From: Borski, Jennifer - DNR
Sent: Wednesday, October 23, 2019 11:53 AM
To: Brian Wayner
Cc: 'kyle.weeks@omni.com'; 'bob.givens@omni.com'
Subject: FW: Miller Electric Melvin St. Parking Lot Proposed Soil Boring Map
Attachments: Proposed Soil Boring Map Melvin Street Parking Lot.pdf; Mauthe_FS_Cr_Soil_Maps.pdf; Mauthe_FS_Soil-GW_Map.pdf; Mauthe_FS_Cover.pdf

Proposed Soil Borings

Subject: Final Feasibility Study Report
N.W. Mauthe Site, Appleton, Wisconsin

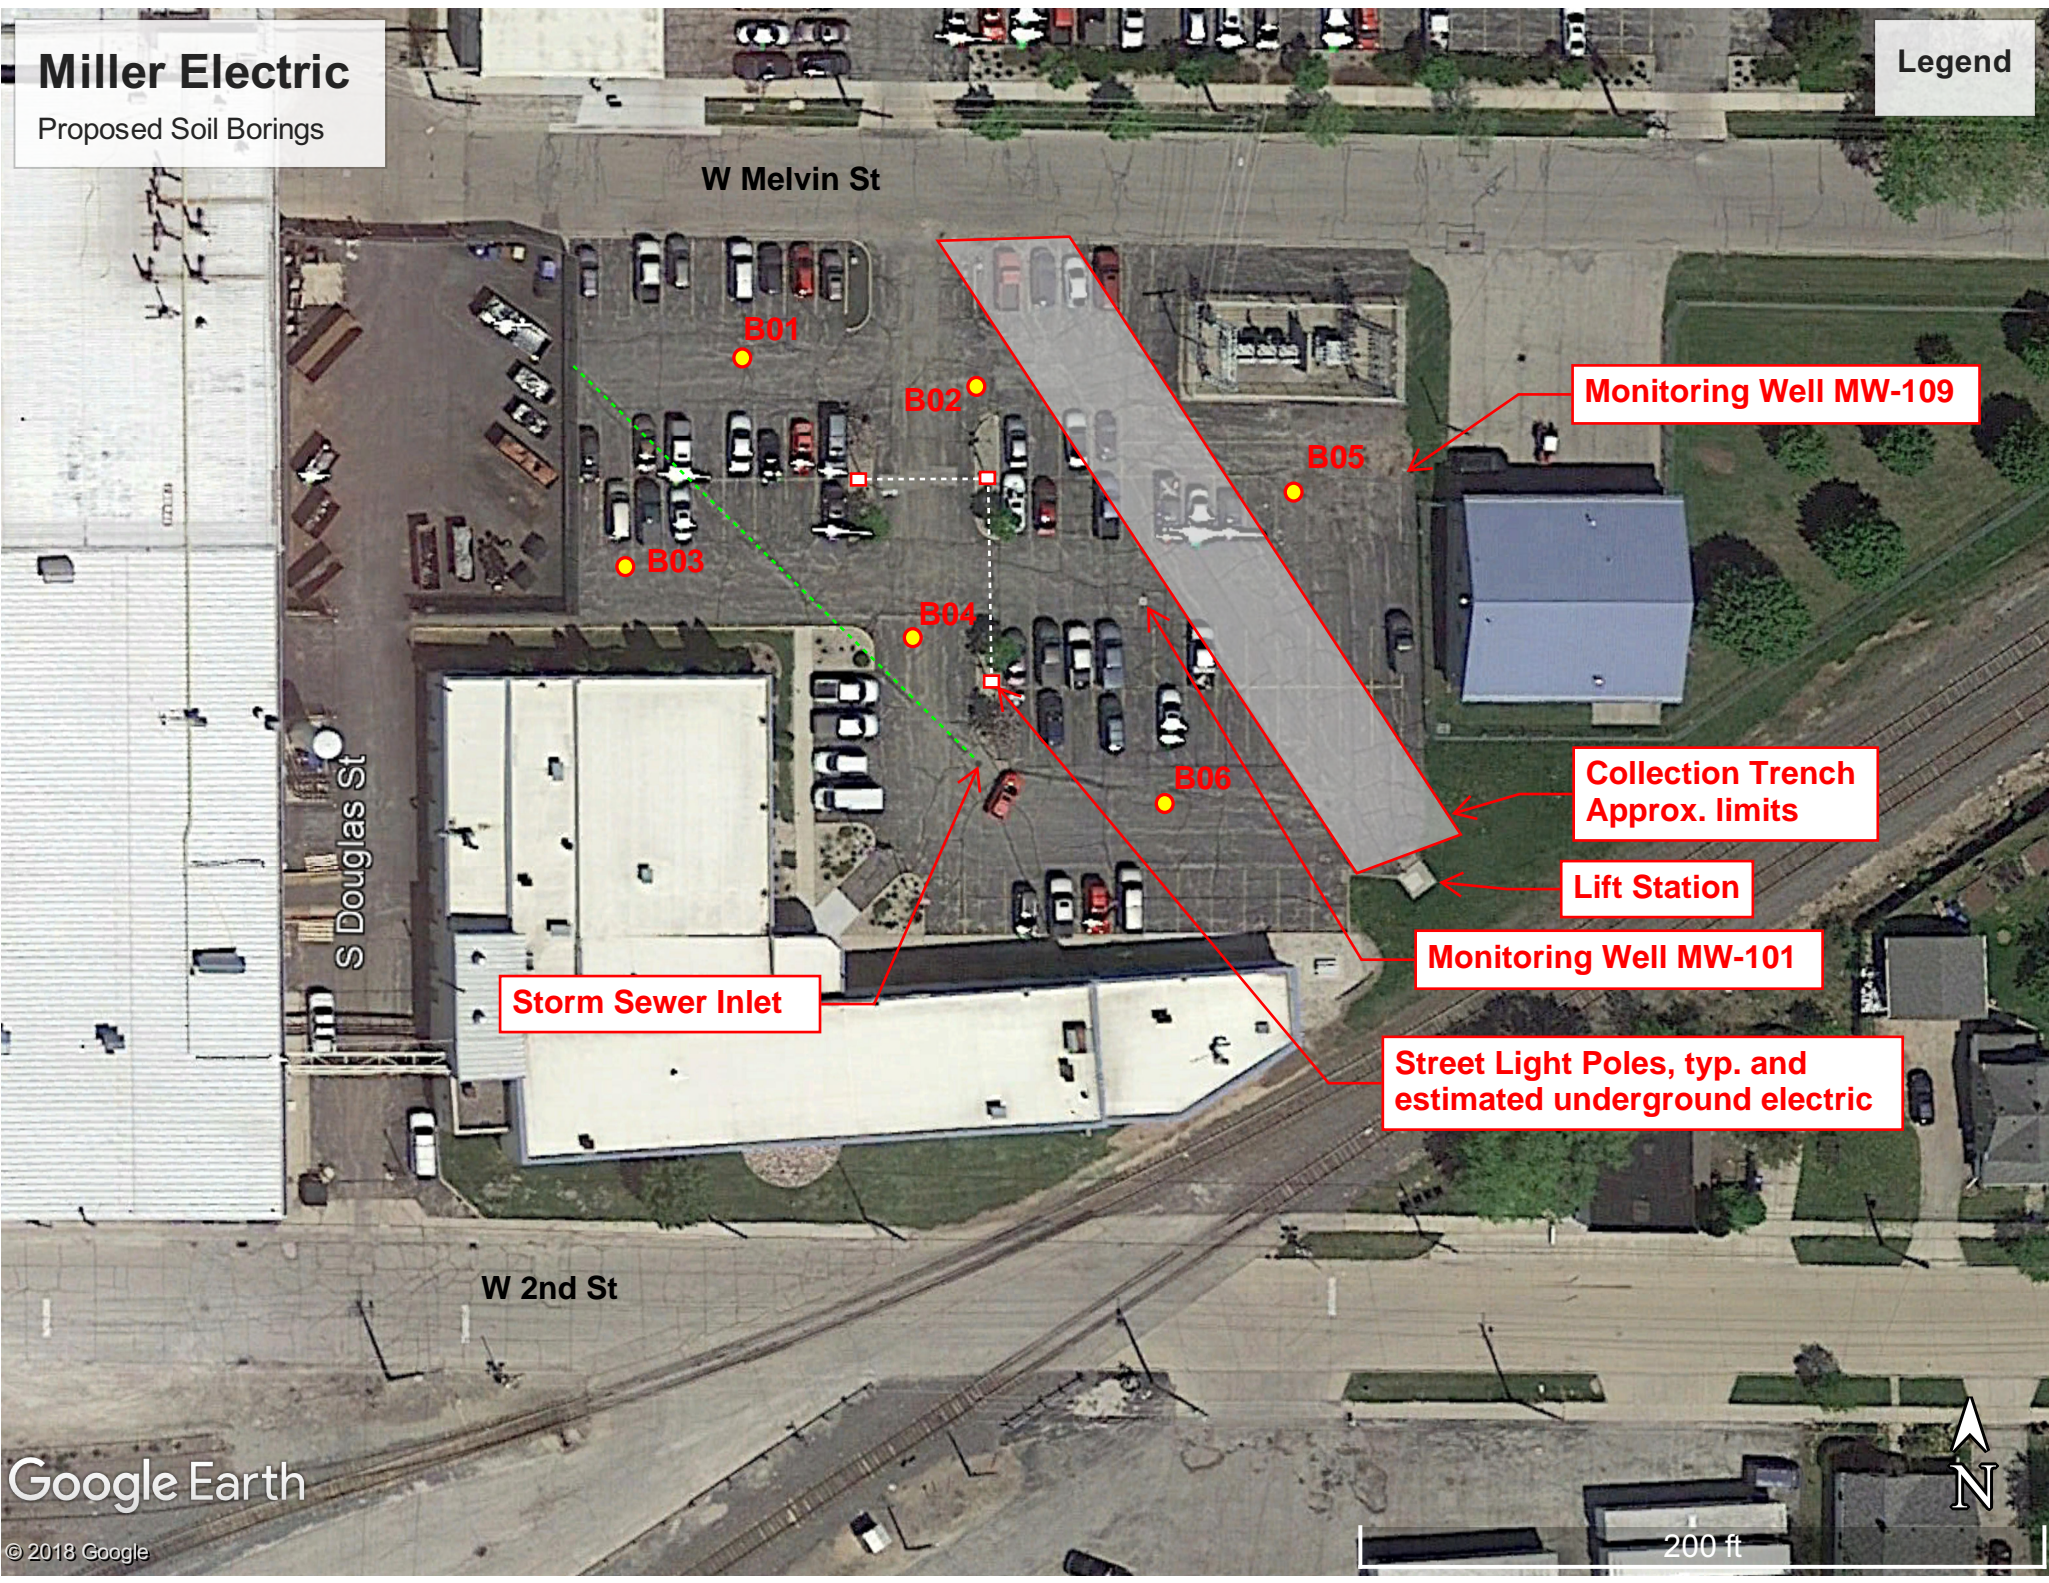
Thank you for the reminder. I reviewed the email chain below and attached proposed soil boring map for B01-B06. I am comfortable with the proposed hand auger boring locations. Thank you for asking and providing time to review.

Resurfacing the lot is not a concern for DNR other than to maintain the integrity of existing monitoring wells, MW-101 and MW-109.

Kyle,
Can you update your map to show the two monitoring wells (MW101 & MW109). I should have pulled the attached map out of the archives earlier.

These boring locations can get moved wherever is needed to stay out of the way.
Can you please send this to Jennifer Borski at WDNR for review? If she has not issue with the "gray-colored" piping trench zone, I may relocate a boring inside that zone for better boring location distribution.

FIGURE 2-3 (Sheet 1 of 2)
Total Chromium Concentrations in Soil
 N.W. Mauthe Site FS Report

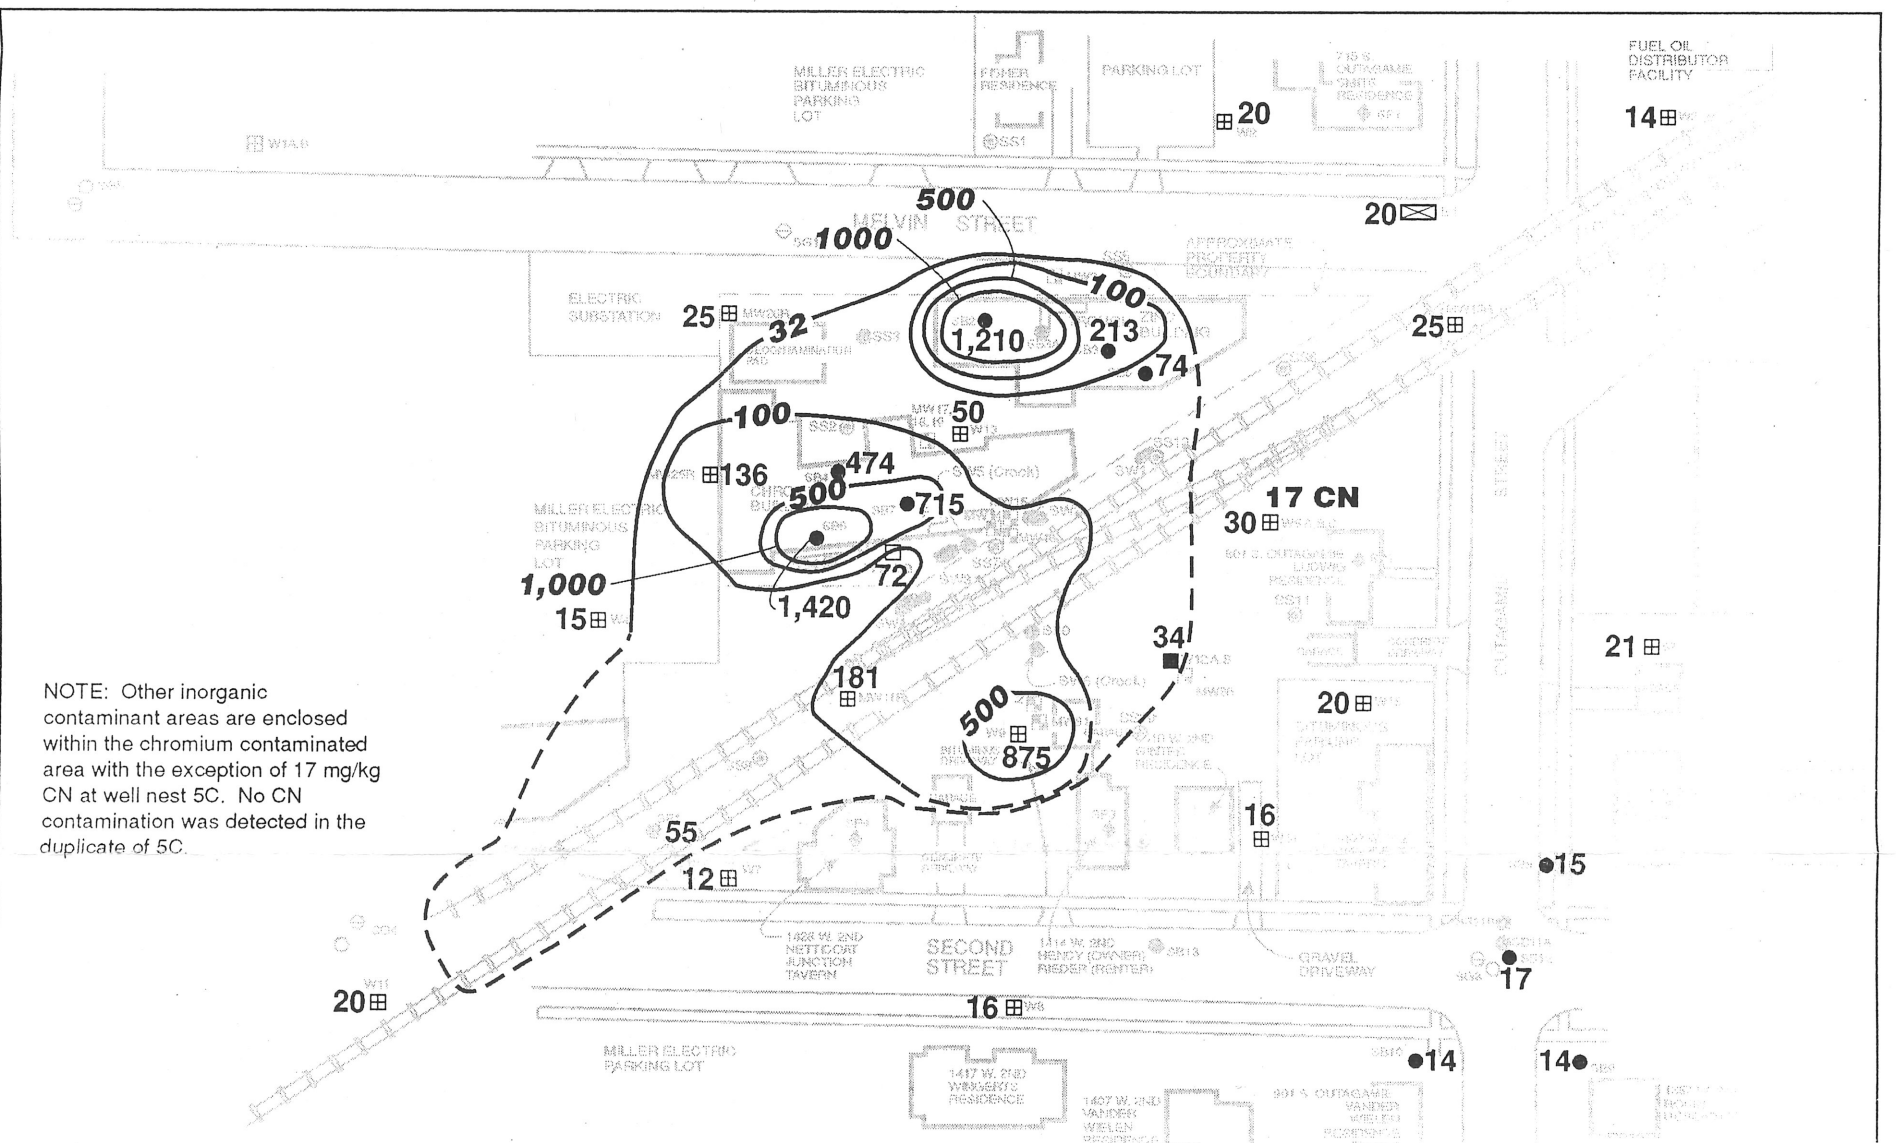
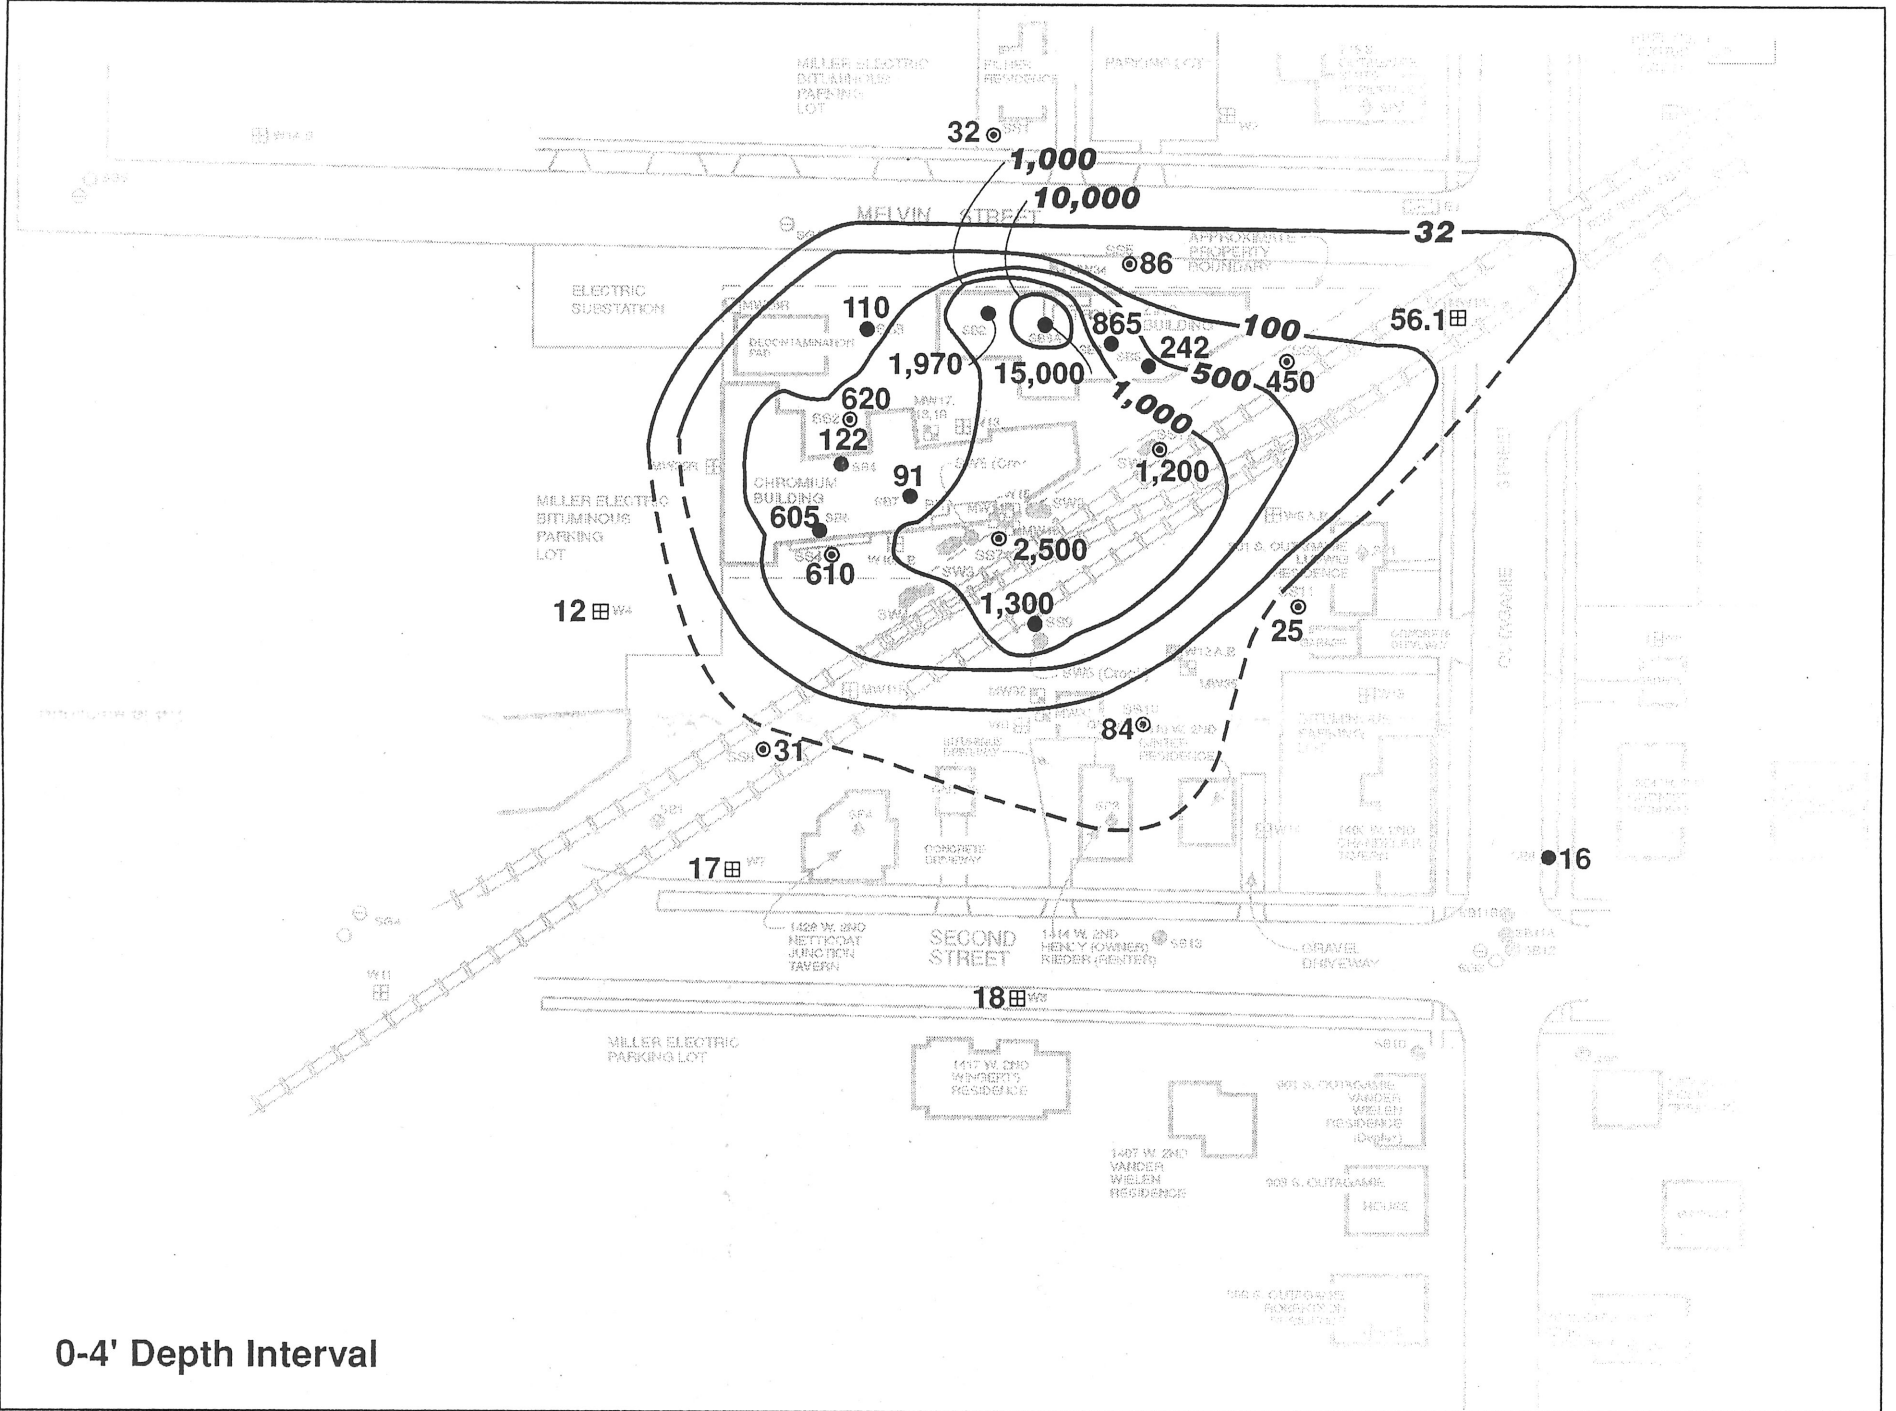
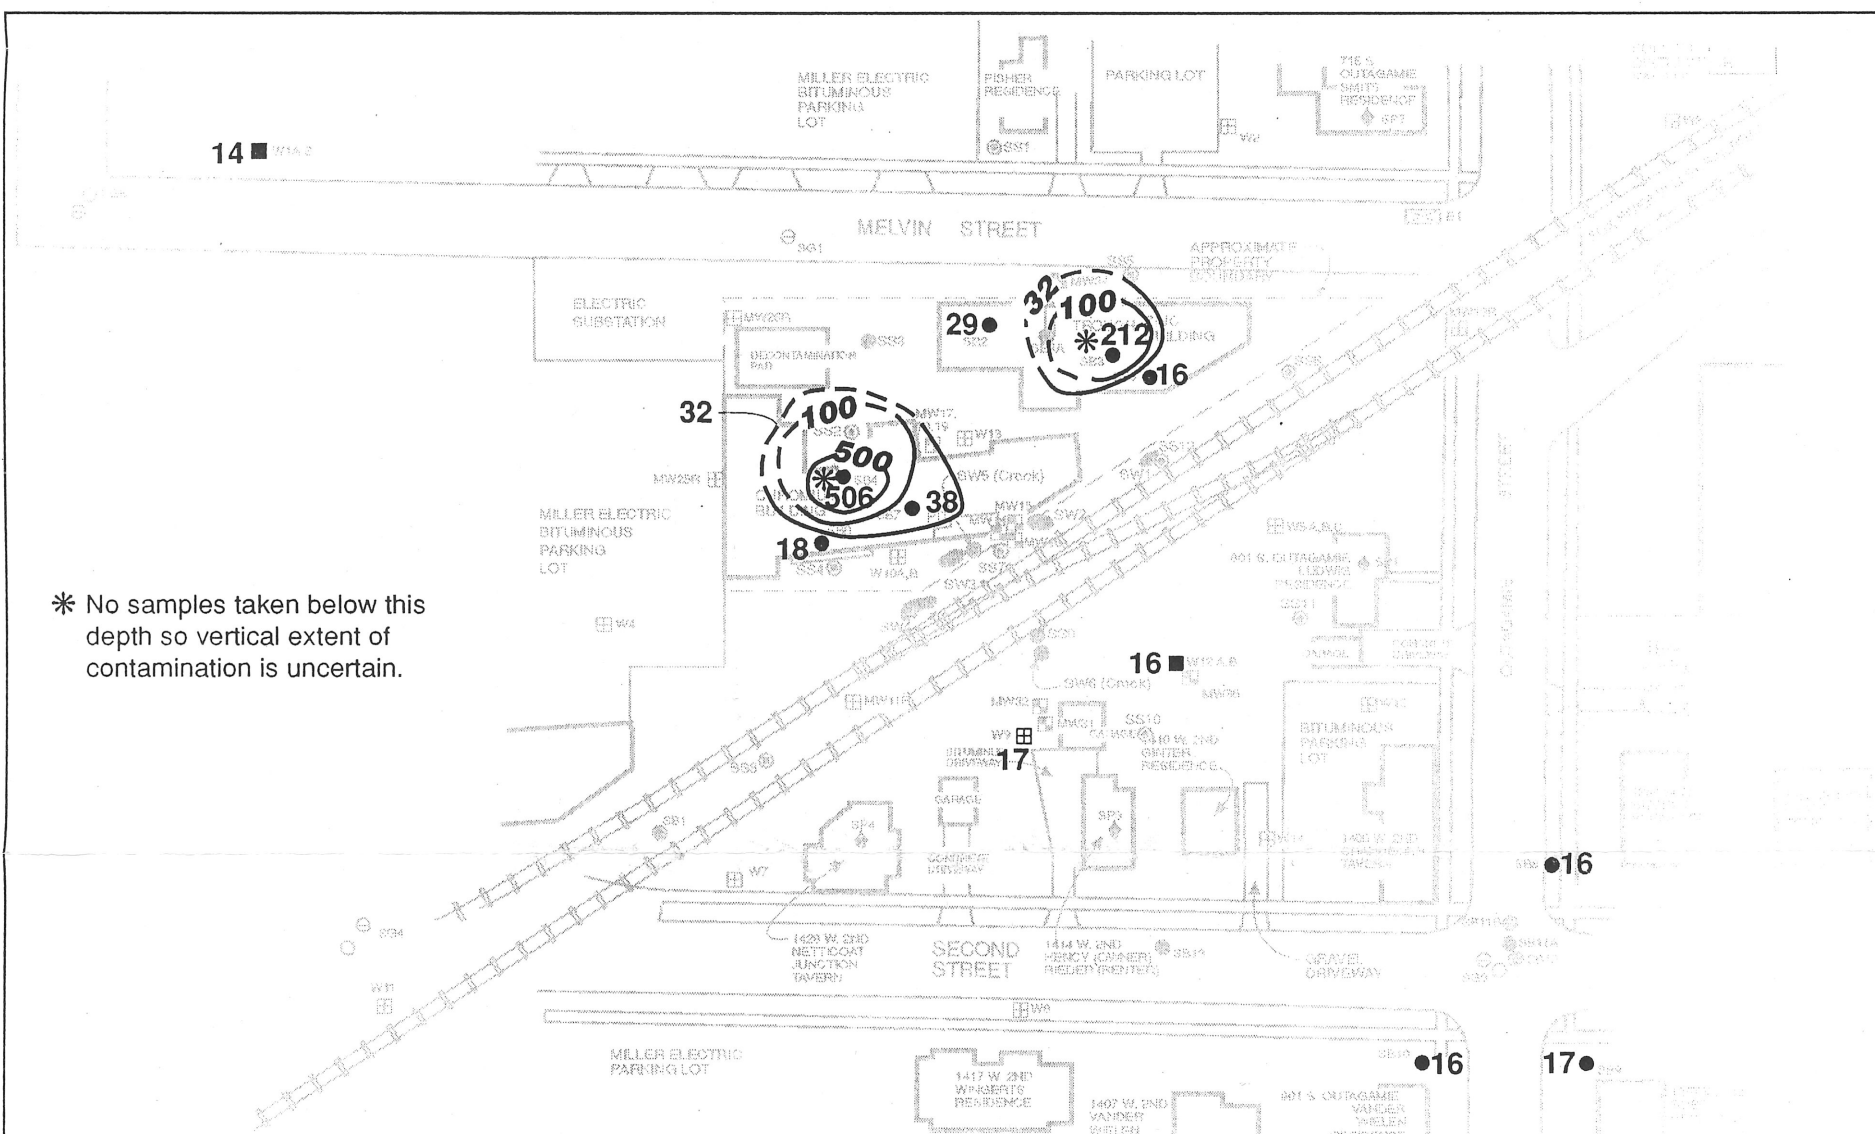
Parking lot replacement that includes removal of the asphalt, sub-base and possibly soil will require further coordination. Please see the attached maps scanned from the May 1993 Feasibility Report that may be of interest. As you are aware, finite delineation of the chromium contamination was not performed by USEPA and documentation of investigation/remedial work performed is also lacking. However, the attached maps provide some insight into possible residual chromium in shallow soil beneath the Miller parking lot.
